E/ECE/324
E/ECE/TRANS/505 } LNG doc. Rev04
25-05-2012

Addendum 109: Regulation No. 110

Regulation No. 110

- I. SPECIFIC COMPONENTS OF MOTOR VEHICLES USING COMPRESSED NATURAL GAS (CNG) **AND /OR LIQUIFIED NATURAL GAS (LNG)** IN THEIR PROPULSION SYSTEM;
- II. VEHICLES WITH REGARD TO THE INSTALLATION OF SPECIFIC COMPONENTS OF AN APPROVED TYPE FOR THE USE OF COMPRESSED NATURAL GAS (CNG) **AND /OR LIQUIFIED NATURAL GAS (LNG)** IN THEIR PROPULSION SYSTEM

PROVISIONS REGARDING LNG IDENTIFICATION MARK FOR PUBLIC SERVICE VEHICLES (M2 and M3)

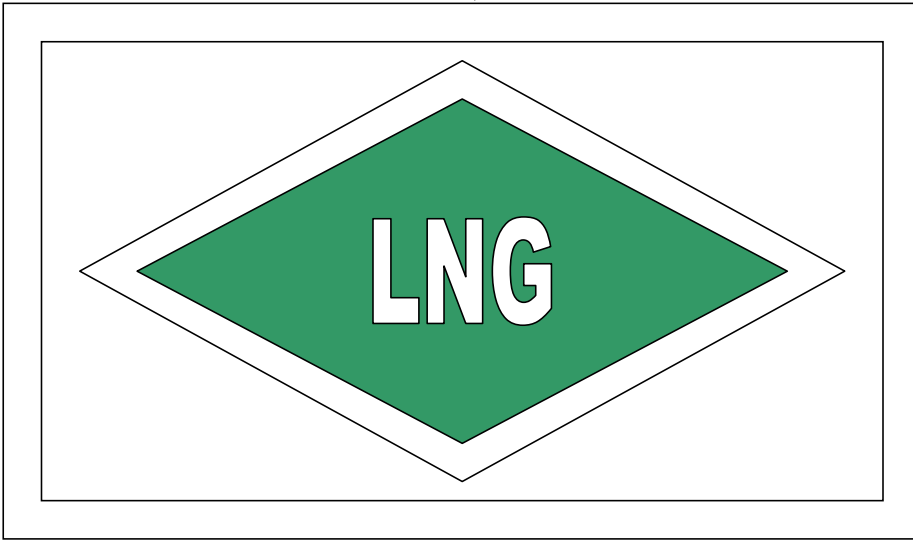
Comment [pc24]: The purpose of this label is to prevent the system for overfilling and not complying with the 5 day hold time.
